Amendments to the Drawings:

REMARKS

§ 103 Rejection of Claims 16-27 and 29-34

FIG. 8

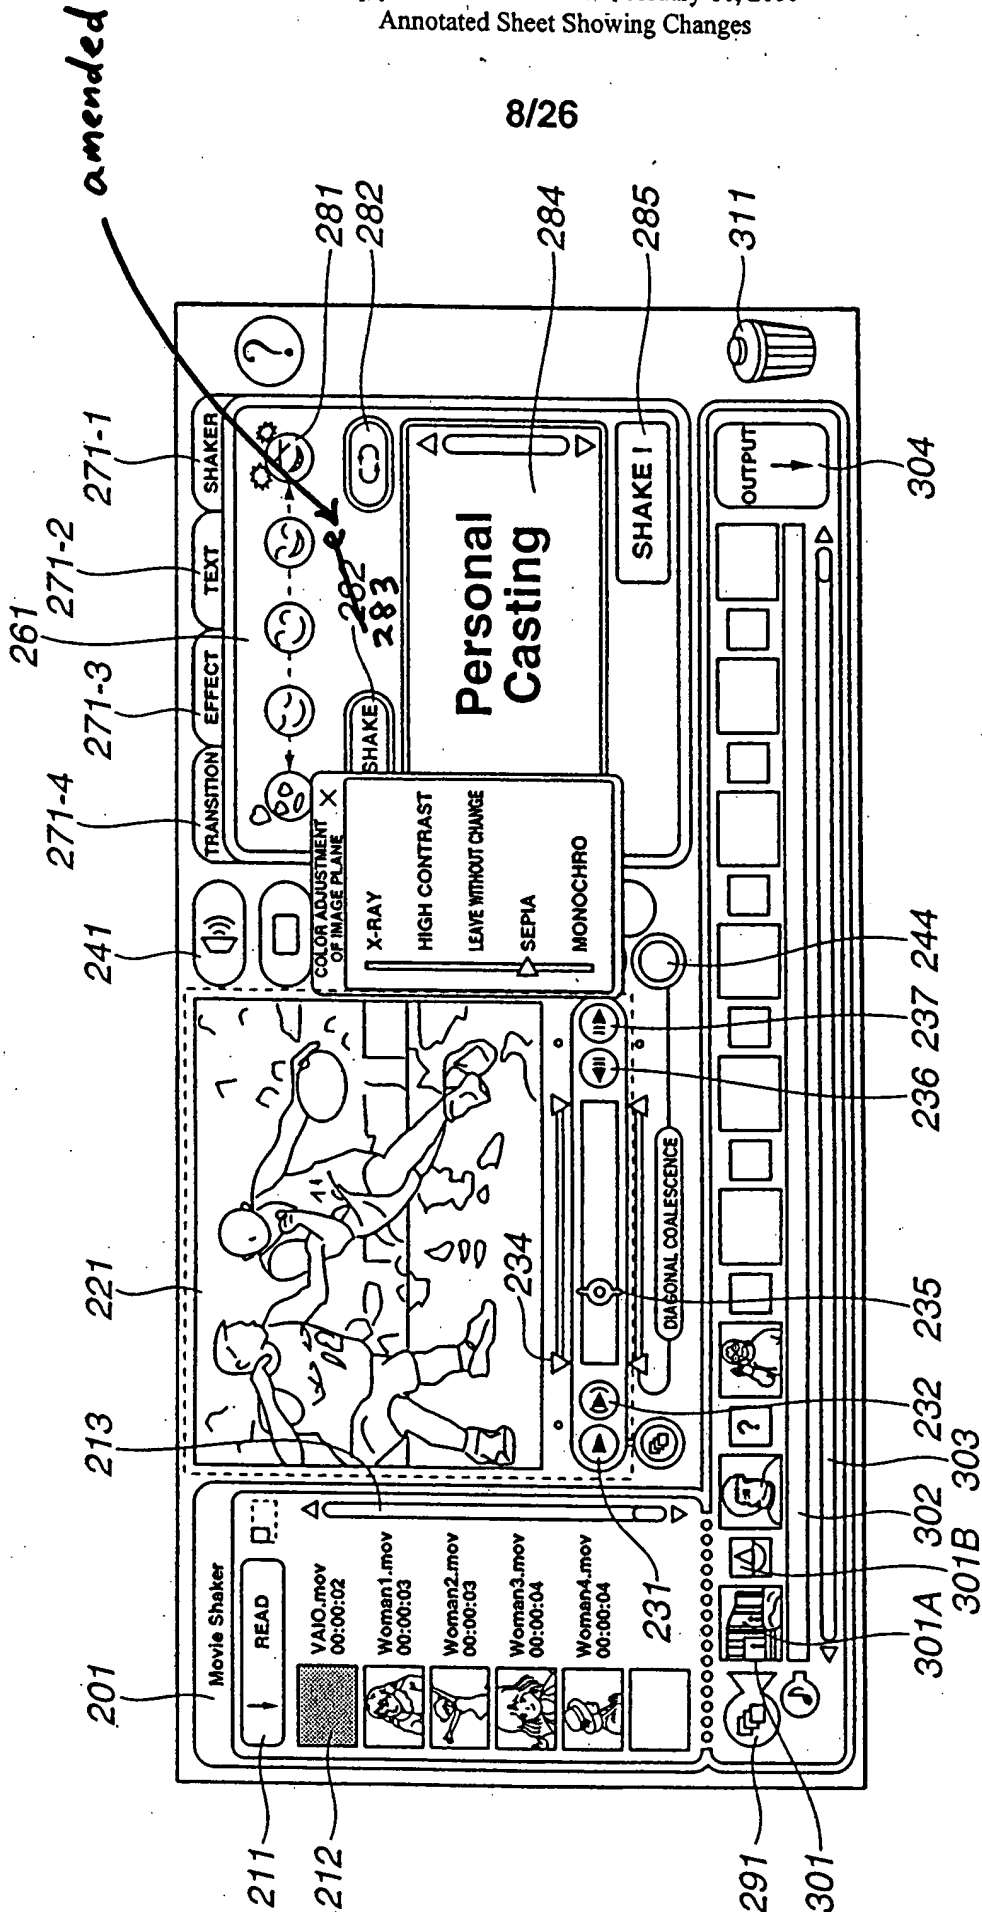
The attached sheets of drawing include changes to Fig. 8. This sheet replaces the original sheet including Figs. 8. In Figure 8, designator '282' designating the "shake" button has been changed from '282' to '283'.

In Section 8 of the Office Action, the drawings stand objected to with respect to reference number "282" in Figure 8. Figure 8 has been amended to obviate this objection.
